Service Bulletin

FEBRUARY

NO. 351

STUDEBAKER

FIG. 1

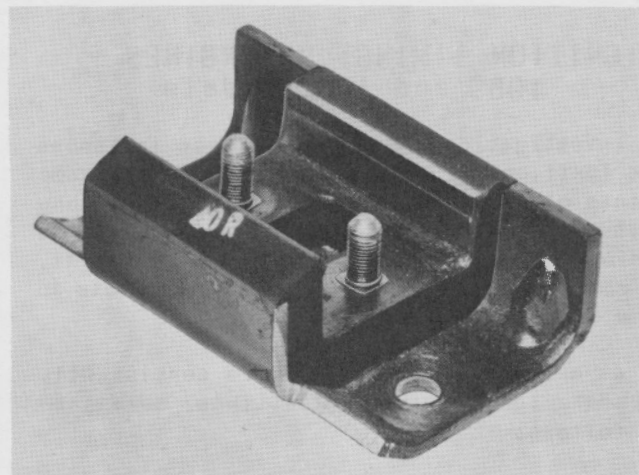
CLUTCH REMOVAL - Y1 Models

When removing and replacing the clutch on models equipped with Engine Rear Support Insulator, Part No. 1550063 (see Fig 1), it is not necessary to remove the crossmember.

To remove the clutch assembly, remove the two nuts and washers holding the insulator to the crossmember. Remove the two cap screws holding the insulator to the clutch housing. Raise the engine and slide the insulator forward and remove it from the crossmember. Push the clutch housing to the rear and rotate until the starter area is adjacent to the crossmember. Remove the pressure plate assembly from the flywheel. Then, the driven plate can readily be removed. To remove the pressure plate assembly, move it toward the starter area in the clutch housing and slip it out from between the clutch housing and engine rear plate. To install, reverse the procedure.

This new type rear support insulator, can be used on all S-Y1 Models.

FIG. 2

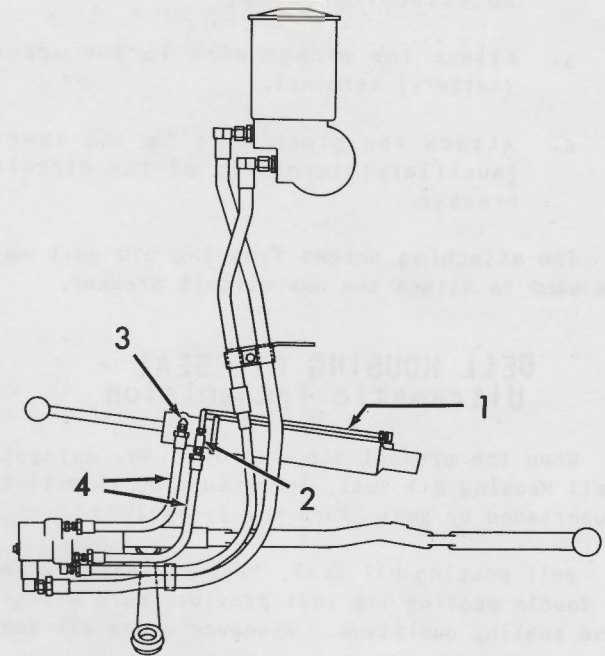
POWER STEERING CYLINDER ASSEMBLIES - Packard

When the supply of Power Steering Power Cylinder Assembly, Part No. 455211, is exhausted, it will be superseded by Power Cylinder Assembly, Part No. 443701.

To accommodate the installation of Power Cylinder 443701 as a replacement for 455211, the following parts will be included with Part No. 443701:

1	443713	Communication Tube
1	G-442346	Tee Fitting
2	G-225810	Elbow
2	446721	Hose, Control Valve-to-cylinder

In line with the assembly substitution, Power Cylinder Tube and Ball Stud Assembly, Part No. 436470, will be substituted for Power Cylinder and Ball Stud Assembly, Part No. 458216, when the supply of Part No. 458216 is exhausted. When the part No. 436470 is supplied, the Connector Fitting, Part No. G-442321, will be included.
